World Forum for Harmonization of Vehicle Regulations

Proposal for Supplement 3 to the original series of amendments to UN Regulation No. 149 (Road illumination devices)

Submitted by the Working Party on Lighting and Light-Signalling*, **

"Figure A4-IX

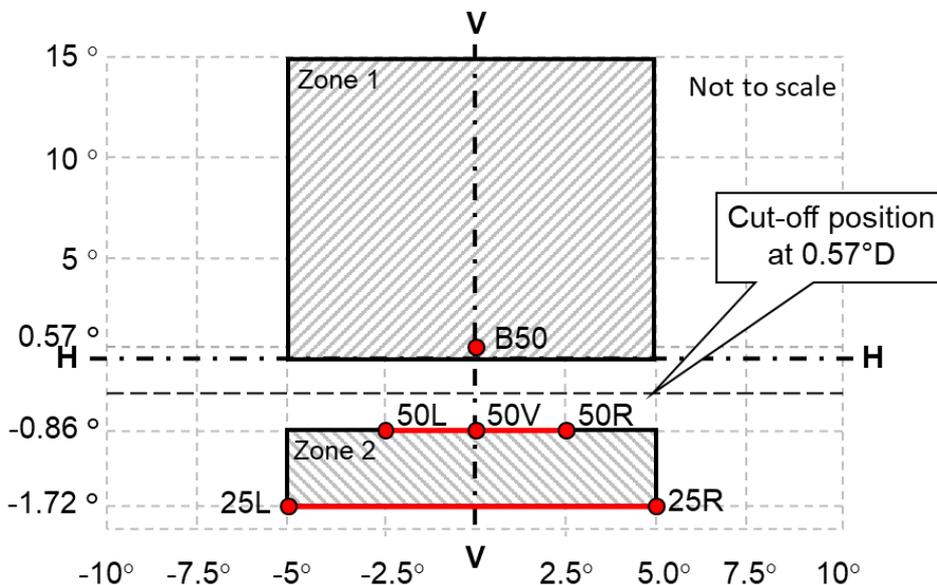
Figure A4-IX; amend to read:

Passing beam test points and zones for Class BS headlamp(s)

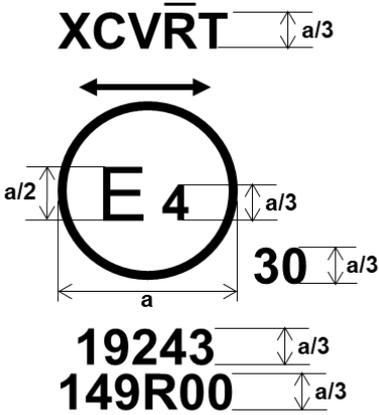
Paragraph 2.1.2.2.1. (a) and (b), amend to read:

(b) Passing-beam, for AFS system:

Class C passing beam and each specified other passing beam class:

50V, B50L and 25LL, if applicable"

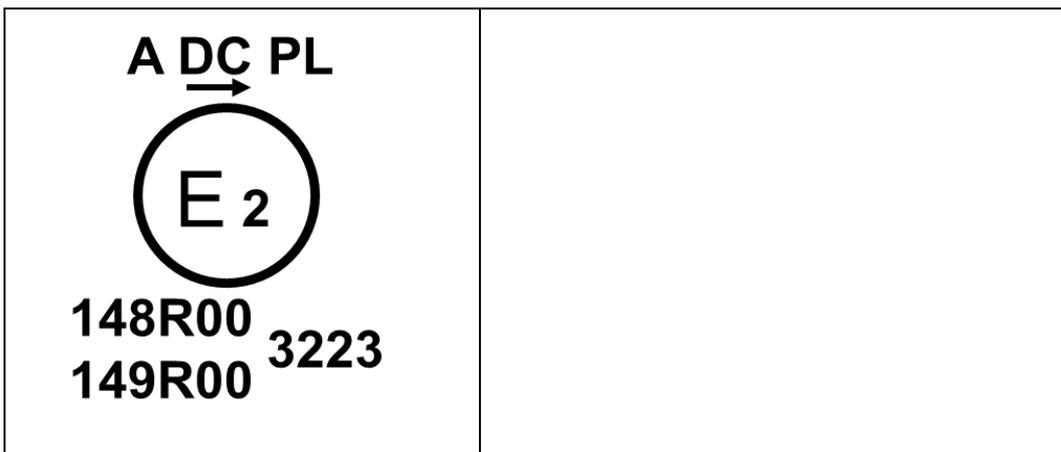
Annex 13, amend to read:

<p>Figure A13-I - Marking example 1</p>  <p>a = see para. 3.3.1.2.1. of this Regulation</p>	<p>The device bearing the approval mark shown on the left is an installation unit of an AFS approved in the Netherlands (E4) under approval number 19243 pursuant to this Regulation.</p> <p>The number after 149R indicates that approval was granted in accordance with the requirements of this Regulation in its original form (00).</p> <p>The functions identification symbols show that the approval was granted in respect of the driving-beam (R) and the Class C and Class V passing-beam. The double pointed arrow shows that the passing beam is suitable for both traffic systems by means of an appropriate adjustment of the setting of the optical element or the light source on the vehicle. Class C passing-beam, Class V passing-beam and driving-beam comply to bending lighting provisions, as indicated by the letter "T". The score above the letter "R" indicates that the driving-beam function is provided by more than one installation unit on that side of the system.</p> <p>Number 30 indicates that the maximum luminous intensity of the driving-beam is between 123,625 and 145,125 candelas.</p>

<p>Figure A13-II - Marking example 2</p>	<p>The lamp bearing the approval mark shown on the left is a gas-discharge passing beam headlamp (DC) for left-hand traffic only (arrow) using a plastic lens (PL) approved in France (E2) pursuant to this Regulation 149R as set in the original series of amendments (00) combined with a front position lamp (A) as set in the original series of amendments (00) of the Regulation on Light Signalling Devices 148R. Both lamps (functions) are approved under approval number 3223.</p>
